IN THE MATTER of the Resource Management Act 1991

IN THE MATTER of a Board of Inquiry appointed under s149J of the Resource Management Act 1991 to consider Notice of Requirements and applications for Resource Consent made by the New Zealand Transport Agency in relation to the East West Link roading proposal in Auckland.

**SUMMARY OF EVIDENCE OF GRAEME ROBERT MCINDOE ON BEHALF OF
AUCKLAND COUNCIL
URBAN DESIGN**

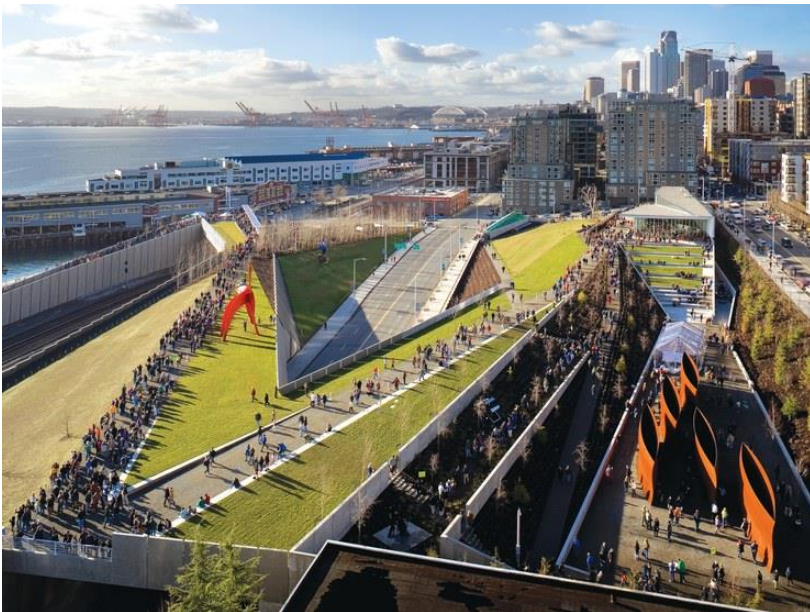
- (c) A land bridge extended from the proposed 70 metres to around 170 metres in length (refer to Figure 3 in my rebuttal evidence) would

adequately mitigate local severance here and help to offset severance effects elsewhere around the Tuff Ring and along the Mangere Inlet. That is:

- (i) It would provide for a suitable spatial and conceptual connection between the Te Hopua tuff ring and the harbour edge at Onehunga Wharf.
- (ii) It would reduce the adverse amenity benefits on the Landing and Onehunga Wharf area.
- (iii) The eastern edge of land bridge should if possible extend to include the path along the axis of the New (Old) Mangere Bridge, straightening that route and providing more direct pedestrian and cycle connectivity to and from the town centre.
- (iv) An extended land bridge would be a partial offset for severance of the western part of the tuff ring from the coastal edge, in that without the connection that is possible here at the south, the entire tuff ring would be severed from the coast.
- (v) It would assist with offsetting severance of Waikaraka Park and Cemetery from the Mangere Inlet.

(d) I am aware that lengthening the land bridge beyond 90 metres may lead to additional complications and constraints. Recognising that those will need to be overcome, multi-disciplinary design investigations would be necessary to determine precise configuration and length, quality of and facilities on its top surface, provision for ventilation openings, and appropriate means of, if necessary, slightly elevating parts of the land bridge at its eastern end. At that end, the land bridge would need to be no higher than the proposed pedestrian/cycle bridge that connects with the New (Old) Mangere Bridge.

(e) That is, constraints should be resolved in a way that achieves a high quality aesthetic and urban space outcome, and appropriately detailed design investigations should be undertaken before an extended land bridge can be ruled out. The relevant condition of consent could be modified to require covering the maximum extent of the trench between

Ch690 and Ch860 with a land bridge that has a minimum length of 90 metres.
